**Re: 40 Island Way -The Standard - Comments Dated 5/20/2024**

Traf Tech Engineering, Inc. has addressed the traffic-related comments prepared by The Corradino Group (comment dated May 20, 2024). The responses to the traffic-related comments are provided below:

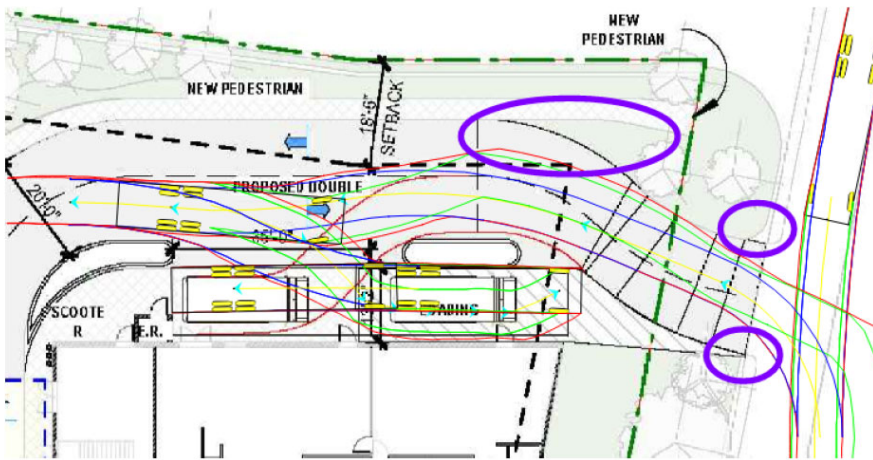
**Comment 8:** Multiple maneuverability exhibits show the design vehicle accessing the site from Island Avenue's opposite direction of travel and/or backing into the site while zigzagging along the proposed horizontal curves of the drive aisle. Please consider modifying the proposed access driveway's radii with a larger one, as well as straightening the access to the site. This will not only assist larger vehicles by easing access to the site but may also help with better visibility while backing into the site. (See snippet below)

**Response 8:** The updated traffic study includes updated AutoTURN superimposed on the latest site plan. As in most cases, trucks tend to use all available pavement widths to park/unpark their large vehicles during the loading/unloading operation.
